A47 North Tuddenham to Easton Dualling

Scheme Number: TR010038

9.15 Alternative Wood Lane Junction Options Appraisal

ALTERNATIVE WOOD LANE JUNCTION OPTIONS APPRAISAL

Figure 2-2: Wood Lane Junction Alternative 1

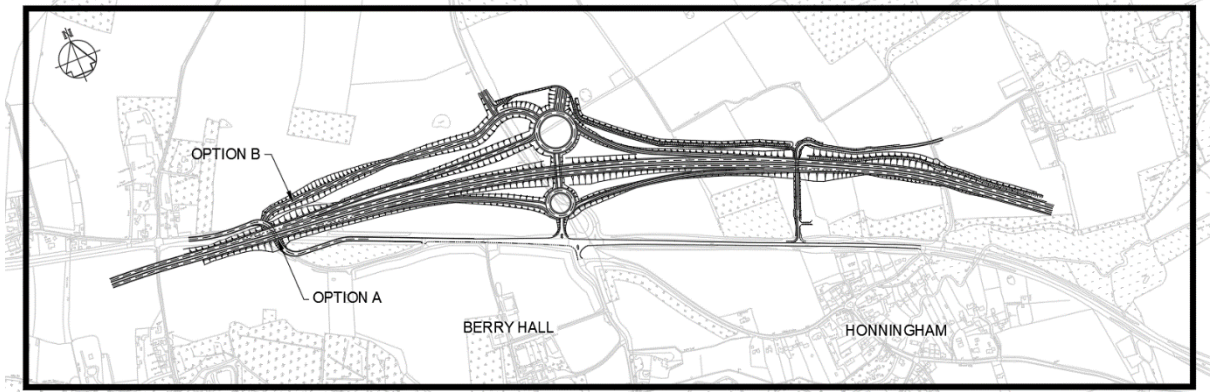
- 3.2.4 The mainline horizontal geometry shown is generally above the desirable minimum radius for a 120kph design speed and therefore complies with the required standards.
- 3.2.5 The exception to this is the 990m horizontal radius used at the eastern tie-in to the developed design. This falls one step below desirable minimum horizontal radius of 1,020m required of a 120kph design speed road and is therefore a horizontal relaxation.

- 3.2.6 As this relaxation occurs in advance of the junction diverge slip, widening to provide full stopping sight distance would be necessary to avoid this being classified as a “Departure from standard” (CD 109, Clause 2.13).
- 3.2.7 This has not been accounted for in the alternative design and would increase permanent land take accordingly.
- 3.2.8 The new mainline alignment would be closer to residential properties at Hall Farm, thus increasing likely noise impacts for properties already predicted to experience a significant adverse residual noise effect during operation of the Scheme design; see Environmental Statement Chapter 11 Noise and Vibration (**APP-150**).
- 3.2.9 Option A, with Lady’s Grove underpass, would also bring the proposed existing A47 side road closer to Hillcrest Cottage compared to the Scheme design.

- 3.2.24 An additional underpass is required in this option to maintain the existing A47. Such an underpass would require a headroom of 5.3m. Provision of this compliant headroom would require the proposed dualled A47 to be raised by approximately 5.3m.

- 3.2.25 The mainline would require to be raised above the Scheme design levels for a length of approximately 1,200m, with additional earthworks/materials and increased environmental impacts, especially landscape, visual and noise for properties around Church Lane, Sandy Lane and Park Lane, over this extent as a result. In particular, there is a risk to:

3.3.16 Indicative slip roads are shown to a similar length of the Scheme design, but do not take into account that the A47 mainline levels would require to be raised west of the junction to accommodate the proposed Lady's Grove underpass carrying the existing A47.

3.3.17 The eastbound diverge and westbound merge slips would not meet the UK DMRB requirements in their current form, due to the increased level difference to be overcome between the junction roundabout(s) and the mainline.

- 3.3.18 Based on the current slip road lengths a non-compliant vertical profile would be required to meet this level difference, resulting in critical departures from standard for both vertical geometry and stopping sight distance which would present safety issues within the conflict area of the junction.
- 3.3.19 Compliant slip roads would only be possible for this alternative layout by significantly increasing the length of the slip roads, resulting in increased land take and associated increase in environmental impacts.
- 3.3.20 The increased lengths in slip roads may require the alternative mainline A47 to move further south, which would impact the proposed Wood Lane Junction location with a similar shift to the south, resulting in operational difficulties with the proposed junction on the existing A47 south of Wood Lane junction.

Figure 2-3: Wood Lane Junction Alternative 2

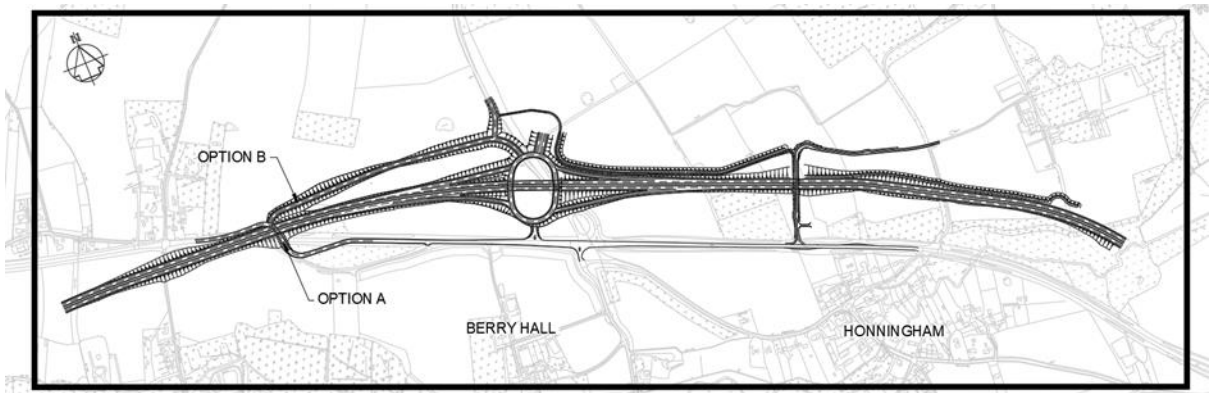
- 3.2.10 The mainline horizontal geometry shown falls below the desirable minimum radius for a 120kph design speed in two locations:
- A 720m horizontal radius is used east of the farm access underpass.

- A 720m horizontal radius is used at the eastern tie-in to the developed design.
- 3.2.11 Both these fall one step below desirable minimum horizontal radius of 1,020m required of a 120kph design speed road and are therefore horizontal relaxations.

- 3.2.12 As these relaxations occur in advance of the junction diverge slip, widening to provide full stopping sight distance would be necessary in order to avoid this being classified as a departure from the standard (CD 109, 2.13).

- 3.2.13 This has not been accounted for in the alternative design and would increase permanent land take accordingly.
- 3.2.14 Option A, with Lady’s Grove underpass, would also bring the proposed existing A47 side road closer to Hillcrest Cottage compared to the Scheme design.

- 3.2.2 The vertical design also needs to provide clearance for two junction underbridges that replace the single structure of the Scheme design.
- 3.2.3 An additional underpass is required in this option to maintain the existing A47. Such an underpass would require a headroom of 5.3m. Provision of this compliant headroom would require the proposed dualled A47 to be raised by approximately 5.6m.

- 3.2.4 The mainline would require to be raised above the Scheme design levels for a length of approximately 1,200m, with additional earthworks/materials and increased environmental impacts, especially landscape, visual and noise for properties around Church Lane, Sandy Lane and Park Lane, over this extent as a result. In particular, there is a risk to: the Scheme design's 'no significant effects' assessment for Noise Important Area 5201 in Environmental Statement Chapter 11 Noise and Vibration (**APP-050**); and the effectiveness of the proposed noise barrier 3 mitigation north of Church Lane could be compromised as mitigation for properties at risk of significant noise impacts from the Scheme design. These features are shown on Sheet 2 of Environmental Statement Figure 11.2 (**APP-074**).
